# **London 2012 Olympic Park**

Consolidated Validation Report (Stage 3) -  
Planning Delivery Zone 3

**July 2013**

DRAWING 7  
LOCOG VALIDATION  
AREAS

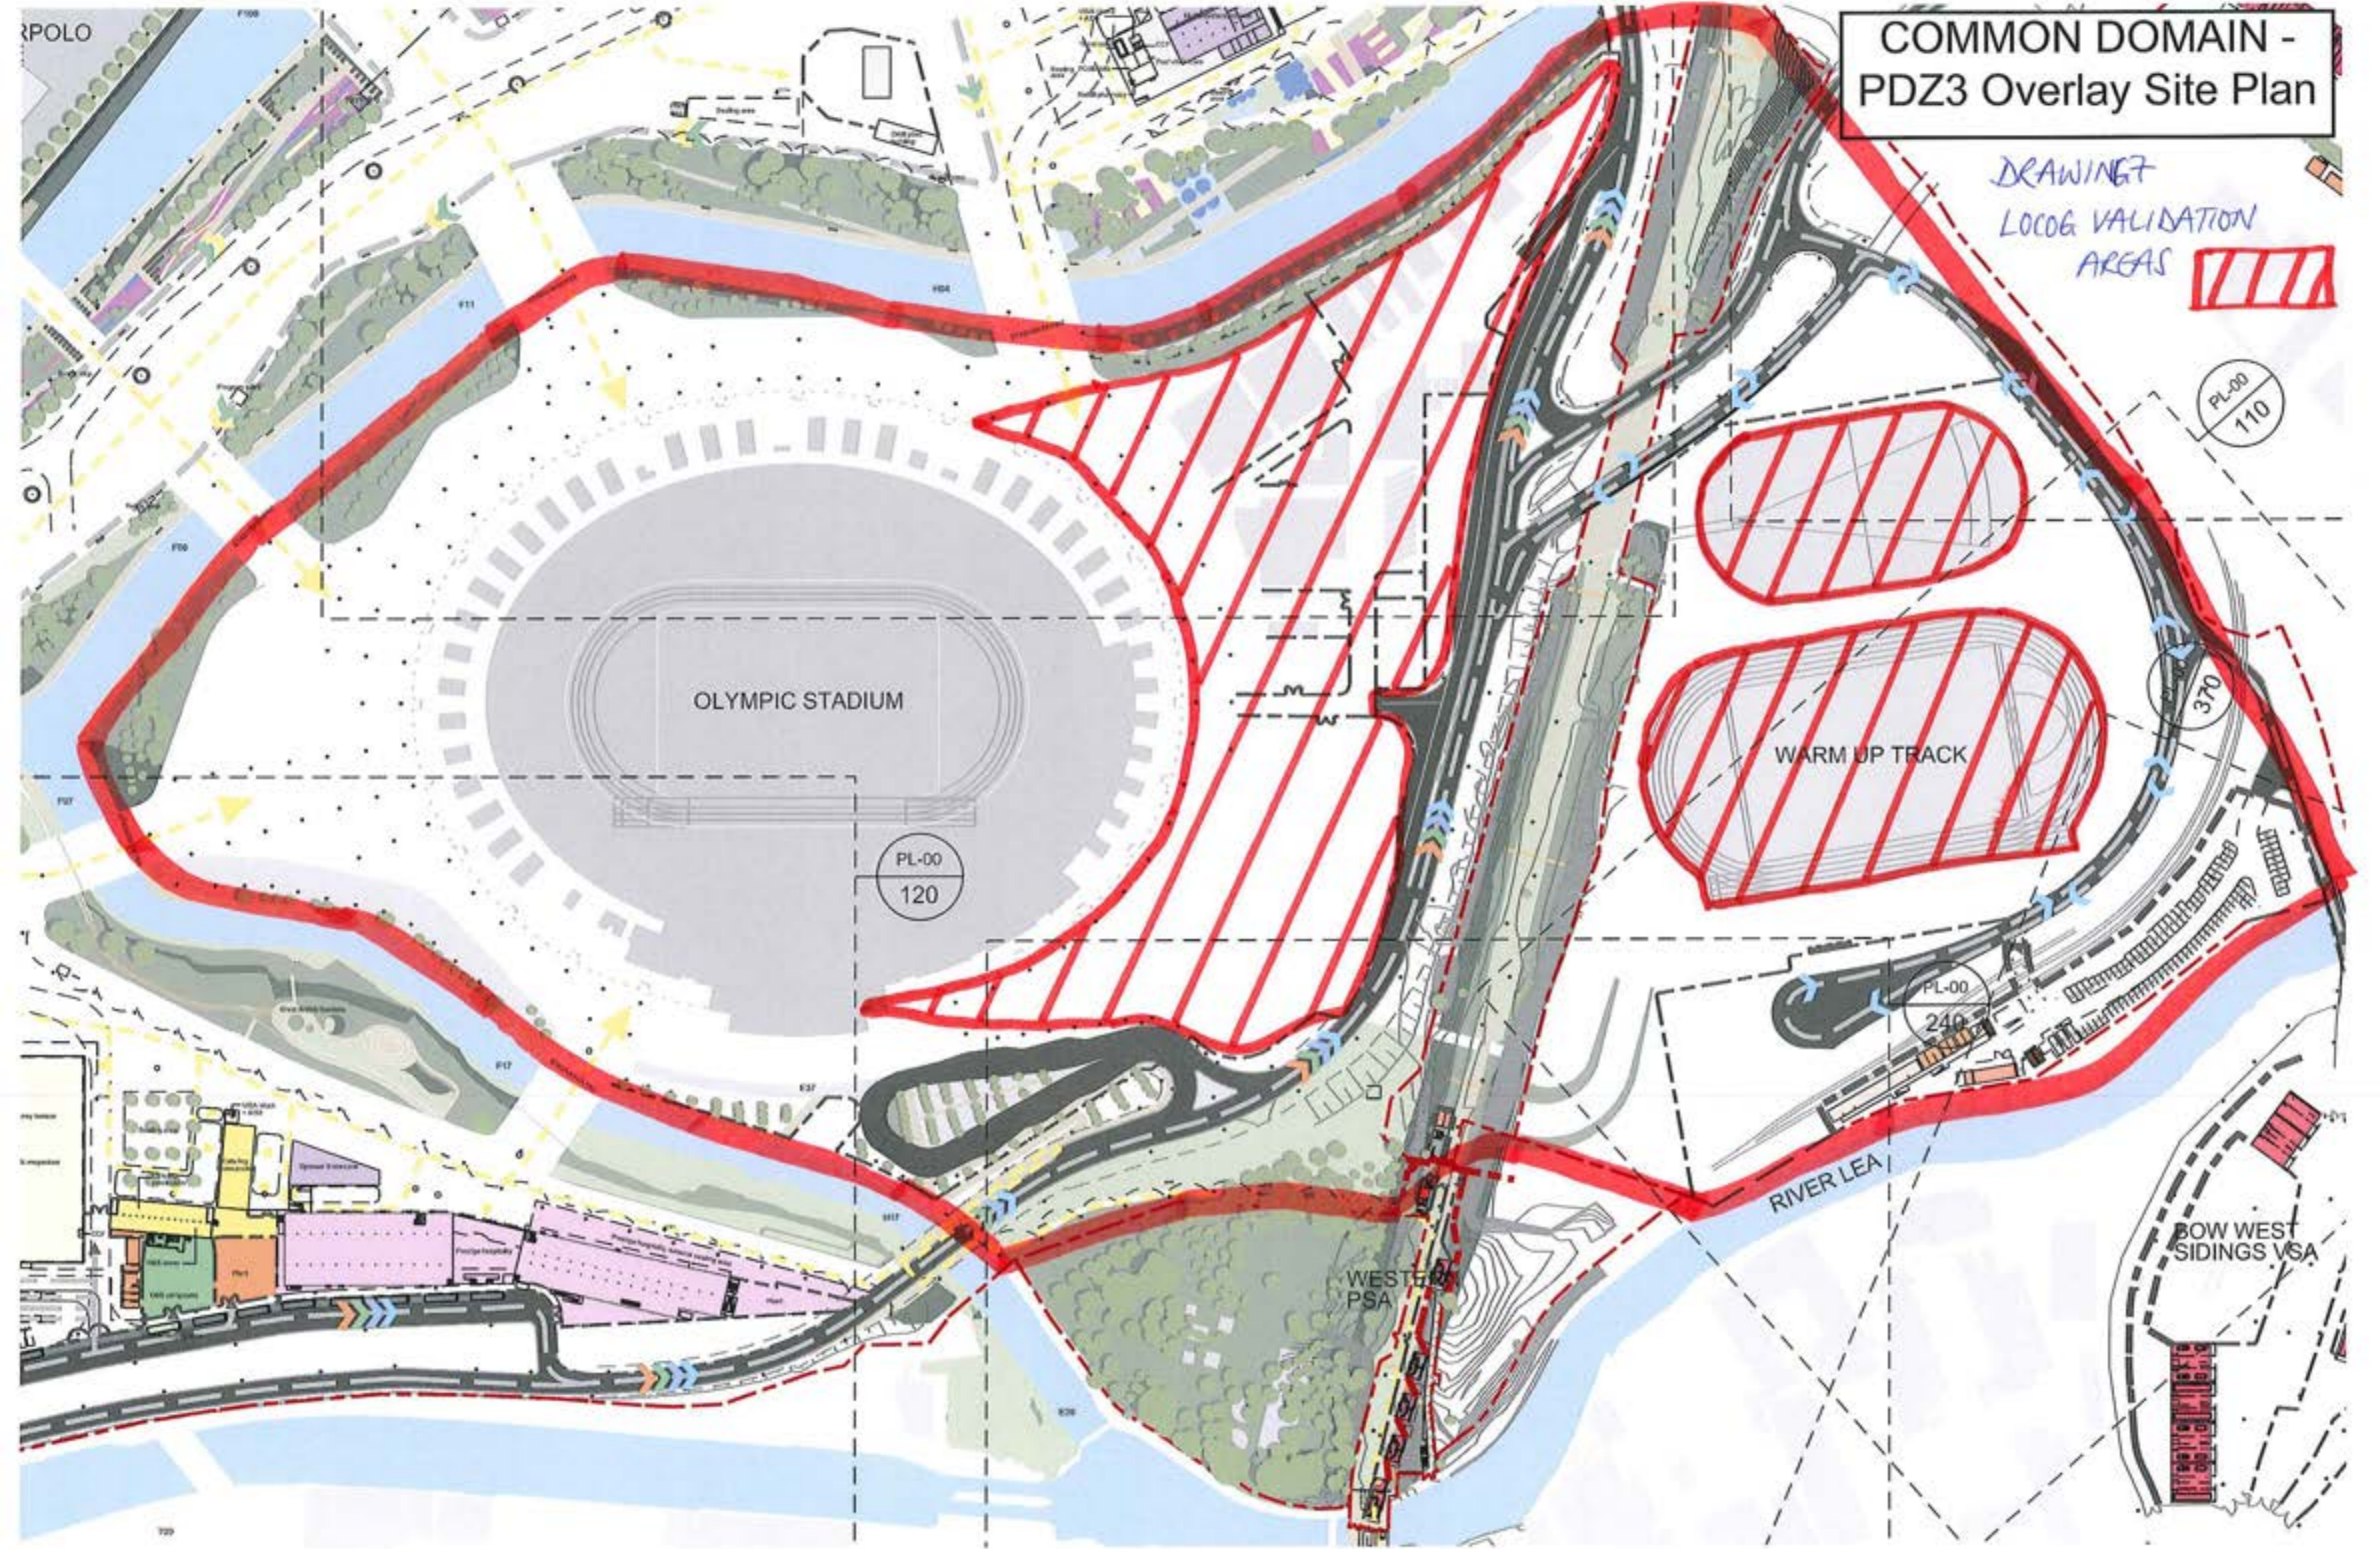
1.22	Spatial coverage of reports	<p>A simple drawing showing the spatial extent of the LOCOG / Showcase validation reports should be included in the report, even if a hand-drawn mark-up.</p> <p><b>Response 07/06/2013: Drawing 7 has now been included which shows the approximate validation area / coverage for LOCOG's works.</b></p> <p><b>Hyder review 13/06/13: No further comment.</b></p>
